We would like to inform you about the following product changes of our **PCB Connectors 713 Series**

2. Geometry changes

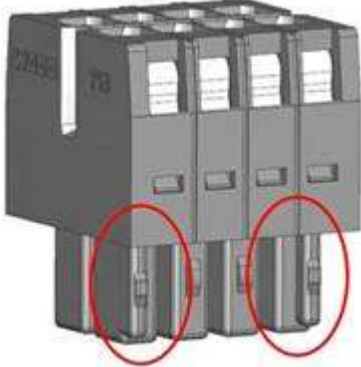
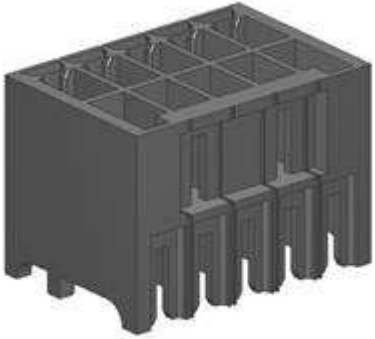
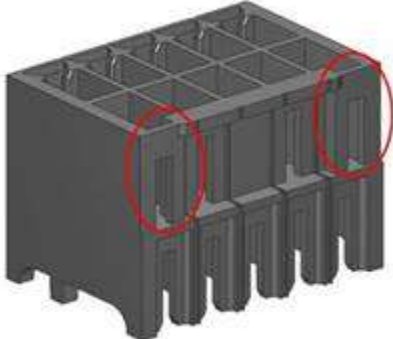
With this change we improve the handling of the connector. The customer benefit is increased by optimizing the insertion and release forces of the pole numbers 2x3 to 2x5, while the insertion and release forces maintain the current level for higher pole numbers. This ensures a consistently easy handling of the 713 Series connector family.

Current Version	New Version
Female Connector (The geometry change affects all pole numbers)		
Male Header (The geometry change only affects the number of poles 2x3 to 2x5)

The overall dimensions and technical data of the new versions are identical to the current versions. UL and EN/IEC certification data are identical and certifications remain valid.
